ECE/TRANS/WP.11/2007/8
25 July 2007

Working Party on the Transport of Perishable Foodstuffs

PROPOSALS OF AMENDMENTS TO THE ATP

Annex 1, Appendix 2, paragraph 49, proposal for the number of temperature measuring points

Figure 1

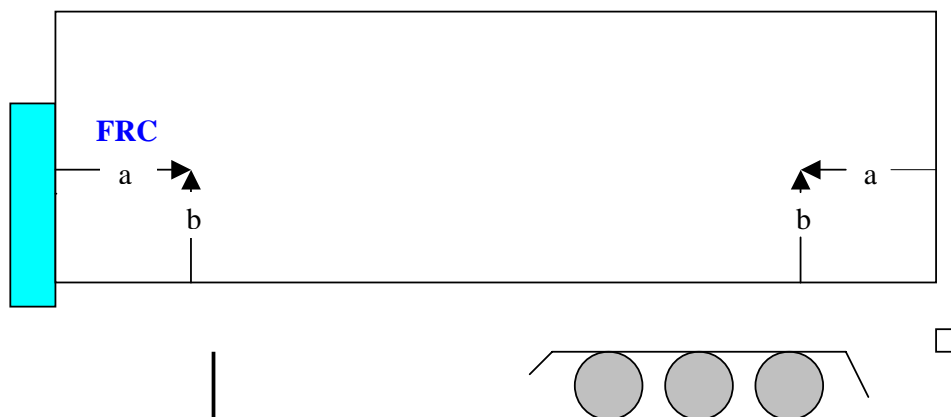
Temperature measuring instruments protected against radiation shall be placed inside the body and outside the body. The instruments inside the body shall be placed at the points specified below (see figure 1).

For measuring the inside temperature of the body (T_i), at least 2 temperature measuring instruments shall be placed inside the body at a maximum distance of 50cm from the front wall, 50cm from the rear door at a height of min. 15 cm and max. 20cm above the floor area.

For measuring the outside temperature of the body (T_e), at least 1 temperature measuring instrument shall be placed at a distance of at least 10cm from an outer wall of the body and at least 20cm from the air inlet of the condenser unit.

The final reading should be from the warmest point inside the body and the coldest point outside.
